**SUBDIVISION,
PLANNED UNIT DEVELOPMENT
& ZONING AMENDMENT STAFF REPORT****Date: July 18, 2019****APPLICANT NAME**

Magnolia Manor Subdivision

LOCATION1624 Spring Hill Avenue
(North side of Spring Hill Avenue, 100'± East of USA
Childrens and Womens Parkway).**CITY COUNCIL
DISTRICT**

CONTEMPLATED USESubdivision approval to create one legal lot of record,
Planned Unit Development approval to allow multiple
buildings on a single building site, and Rezoning from R-1,
Single Family Residential District, to B-2, Neighborhood
Business District.**It should be noted, however, that any use permitted in
the proposed district would be allowed at this location if
the zoning is changed. Furthermore, the Planning
Commission may consider zoning classifications other
than that sought by the applicant for this property.****TIME SCHEDULE
FOR DEVELOPMENT**

SITE PLAN

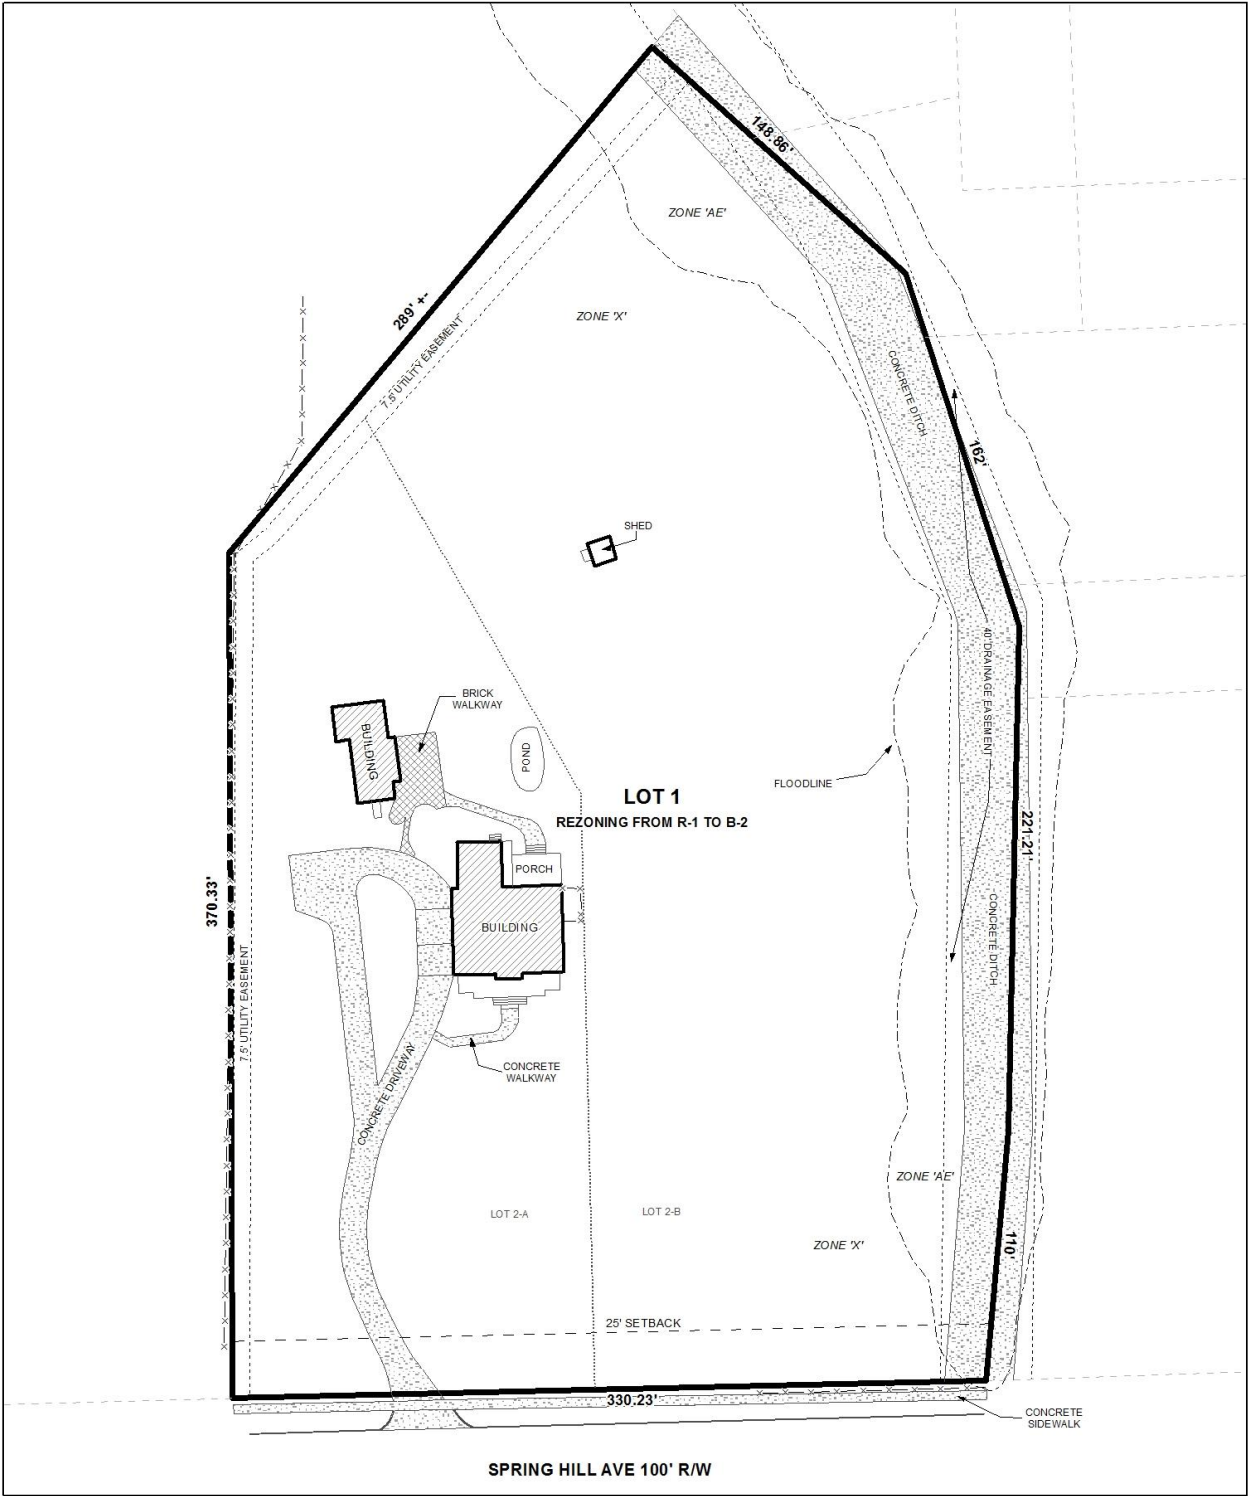
The preliminary Subdivision plat and PUD site plan illustrate the proposed 1 lot, 3.8± acres subdivision located at the North side of Spring Hill Avenue, 100'± East of USA Childrens and Womens Parkway, in Council District 2. The applicant states that the property is served by public water and sanitary sewer.

The site has frontage on Spring Hill Avenue, a major street with a 100' right-of-way. The preliminary plat and site plan illustrate a 100' right-of-way, thus no dedication will be required. As the site fronts a major street, access management is a concern; therefore a note should be placed on the final PUD site plan and Subdivision Plat requiring full compliance with Traffic Engineering comments.

The lot is depicted in square feet and acres, and should be retained on any future plats or site plans. Also, the 25' minimum building setback line is depicted on both the plat and the site plan and should be retained in any future plats or plans.

There is an existing curb-cut on the site thus a note should be placed on the Final Plat and PUD site plan stating the lot is limited to one curb-cut with any changes in size, location and design to be approved by ALDOT and Traffic Engineering and conform to AASHTO standards.

Multiple easements are illustrated on the plat and site plan, including a 7.5' utility easement along the West and rear property line, and a 40' storm drainage easement along the East of the property. As such, if approved, an additional note should be required on the Final Plat and PUD site plan stating no structures shall be constructed in any easement.

The site is developed with an existing two-story, 3,412 square foot residence, and an 877 square foot detached carriage house. The site plan references a 1,400 square feet for the reception space and a total of 50 parking spaces. The parking ratio for a reception space is one space per four seats. Neither the site plan nor the narrative illustrate how many seats the venue can hold; what the remaining 2,012 square feet of the main structure would be used for; or how the carriage house would be utilized.

There is no dumpster illustrated on the site plan. If approved, the site plan should be revised to illustrate any proposed dumpsters, with any new dumpsters to be in compliance with Section 64-

4.D.9. of the Zoning Ordinance. If no dumpster will be used on the site, such should be noted on the PUD site plan.

Due to the site plan specific nature of PUD approval, it should be noted there appears to be 2 handicap accessible parking spaces on the site, but there does not appear to be any ramps indicated on the plan. The site plan should be revised to depict any modifications or improvements required due to accessibility requirements to include Building Code or ADA.

- 1) revision of the site plan to depict the total square footage of the first and second floors of the main building and the accessory structure;*
- 2) placement of a note on the site plan stating occupancy load not to exceed 200 people;*

- 3) retention of the 25' minimum building setback line;*
- 4) retention of the right-of-way width along Spring Hill Avenue;*
- 5) retention of the labeling of all utility and drainage easements on the site plan;*

- 6) placement of a note on the site plan stating no structures shall be constructed on or within any easements;*
- 7) placement of a note on the site plan stating a vegetative buffer will be provided where the site abuts residentially zoned property;*

- 8) revision of the site plan to illustrate any proposed dumpsters to be in compliance with Section 64-4.D.9. of the Zoning Ordinance, or a note stating curb-side pick will be provided;*
